<b>Well Name:</b> POKER LAKE UNIT	<b>Well Location:</b> T24S / R30E / SEC 7 / NESE /	<b>County or Parish/State:</b> EDDY / NM
<b>Well Number:</b> 180	<b>Type of Well:</b> OIL WELL	<b>Allottee or Tribe Name:</b>
<b>Lease Number:</b> NMLC068545	<b>Unit or CA Name:</b> POKER LAKE DELAWARE C	<b>Unit or CA Number:</b> NMNM71016G
<b>US Well Number:</b> 3001532126	<b>Well Status:</b> Producing Oil Well	<b>Operator:</b> XTO PERMIAN OPERATING LLC

### Notice of Intent

**Type of Action:** Plug and Abandonment

## PLUG AND ABANDONMENT CONDITIONS OF APPROVAL

# Poker Lake Unit #180 - Current and Proposed WBD's

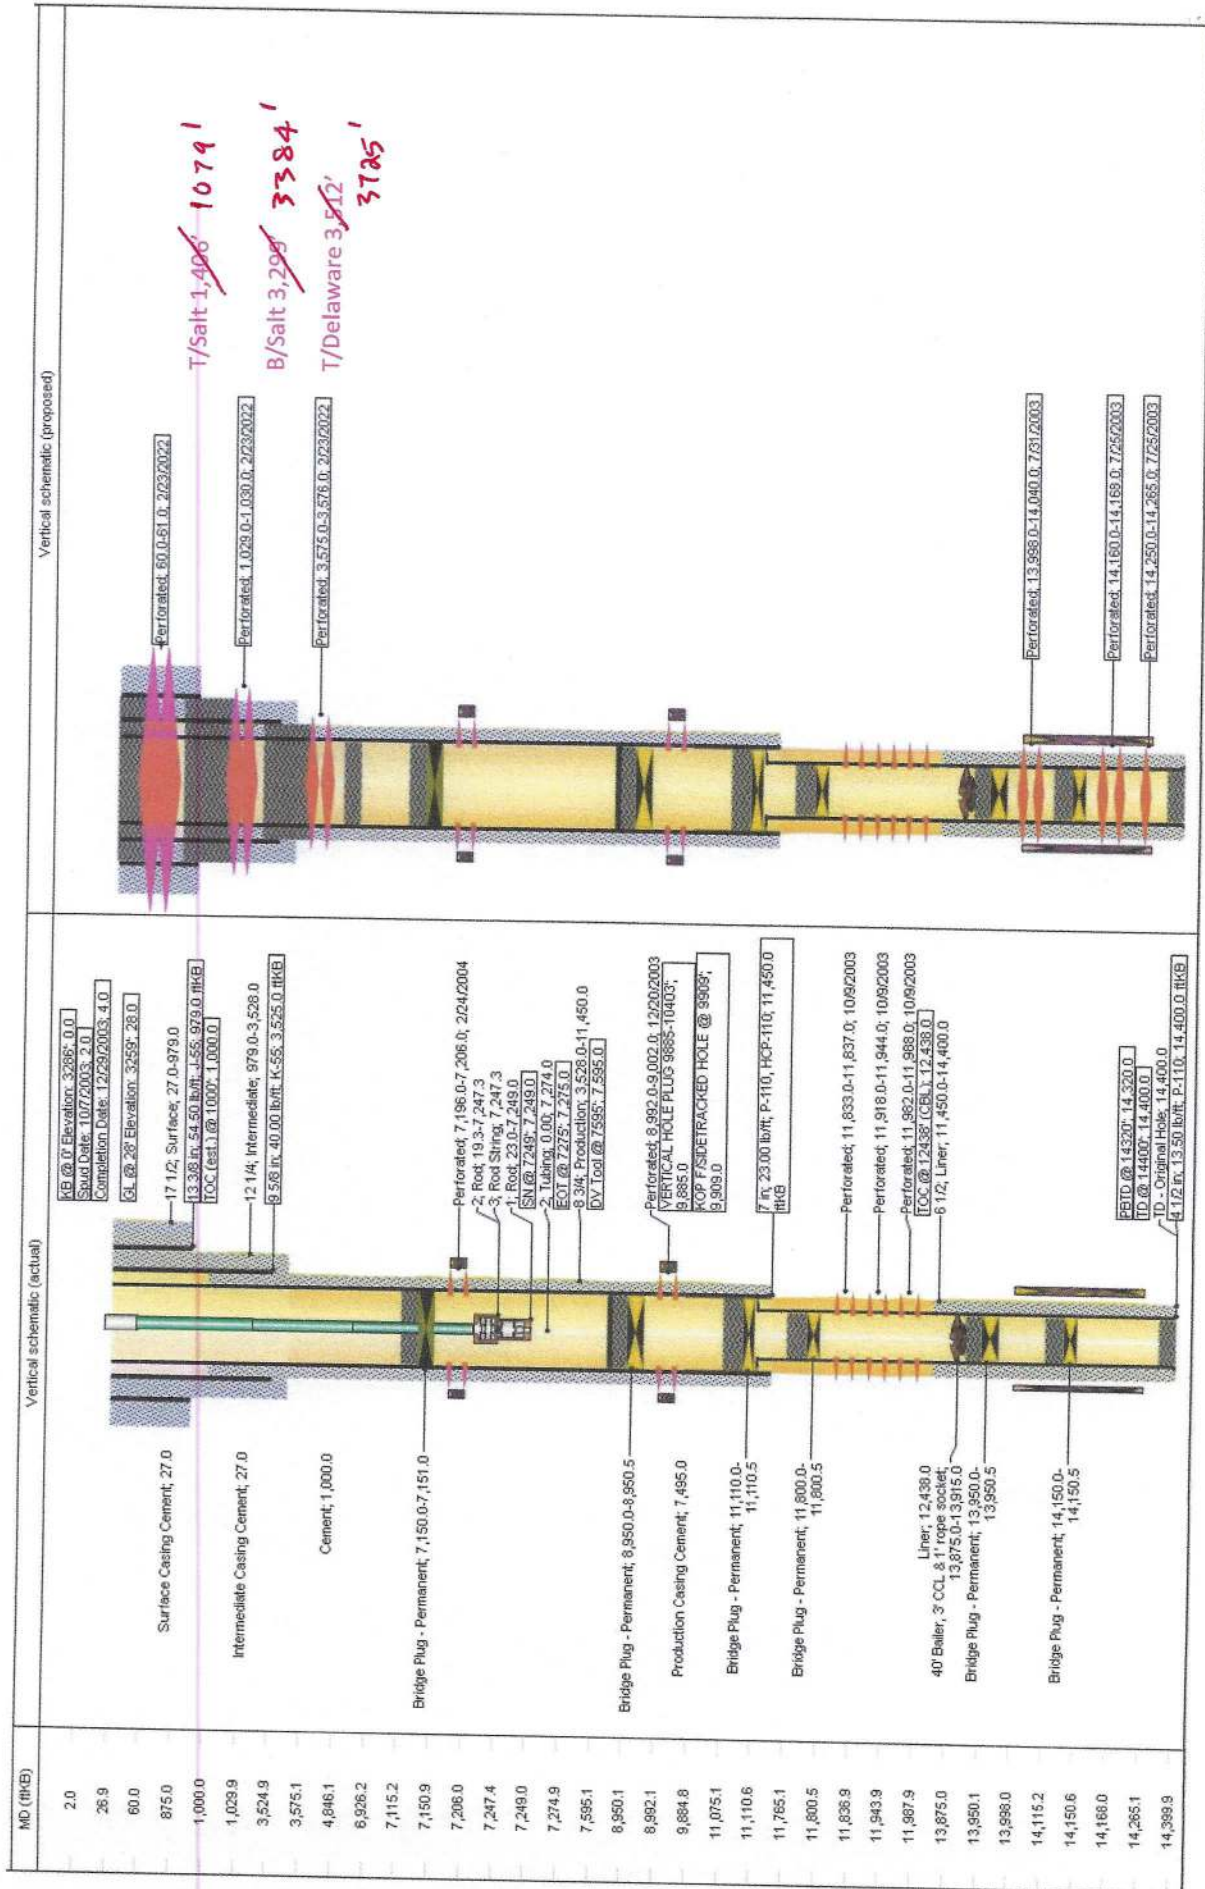
- No more than 3000 feet between cement plugs in cased hole.
- Wait on Cement and Tag Top of Cement Requirement:
  1. Shoe, Top of Salt, Base of Salt, DV tool, Perforate and Squeeze, Open Perforation.
  2. Formation plug is optional if a solid base is established and confirmed.

Sundry ID		2663150				
Plug Type	Top	Bottom	Length	Tag	Sacks	Notes
Surface Plug	0.00	1129.00	1129.00	Tag/Verify		
Shoe Plug	919.21	1029.00	109.79	Tag/Verify		
Top of Salt @ 1079	1018.21	1129.00	110.79	Tag/Verify	175.00	Perf at 1129' squeeze from 1129' to surface. Verify at Surface.
Base of Salt @ 3384	3300.16	3434.00	133.84	Tag/Verify		
Shoe Plug	3439.75	3575.00	135.25	Tag/Verify

If solid base no need to Tag (CIBP present and/or Mechanical Integrity Test), If Perf & Sqz then Tag, Leak Test all CIBP if no Open Perforations		
<b>Delaware @ 3725</b>	3637.75	3775.00	137.25		285.00	Perf at 3775' squeeze from 3775' to 3158'. WOC and Tag.
				If solid base no need to Tag (CIBP present and/or Mechanical Integrity Test), If Perf & Sqz then Tag, Leak Test all CIBP if no Open Perforations		
<b>Bonesprings @ 7289</b>	7166.11	7339.00	172.89			Tag Top of cement plug.
				If solid base no need to Tag (CIBP present and/or Mechanical Integrity Test), If Perf & Sqz then Tag, Leak Test all CIBP if no Open Perforations		
<b>Wolfcamp @ 10579</b>	10423.21	10629.00	205.79			Not Necessary
<b>Shoe Plug</b>	11285.50	11500.00	214.50	Tag/Verify		Not Necessary

No more than 2000' is to be allowed between plugs in open hole, and no more than 3000' between plugs in cased hole.
Class H >7500'
Class C <7500'
Fluid used to mix the cement in R111P shall be saturated with the salts common to the section penetrated, and in suitable proportions, but not more than 3% calcium chloride by weight of cement will be considered the desired mixture whenever possible.
Critical, High, Medium, Secretary : Top of salt to surface If no salt take the deepest fresh water.
R111P: 50' from bottom of salt to surface
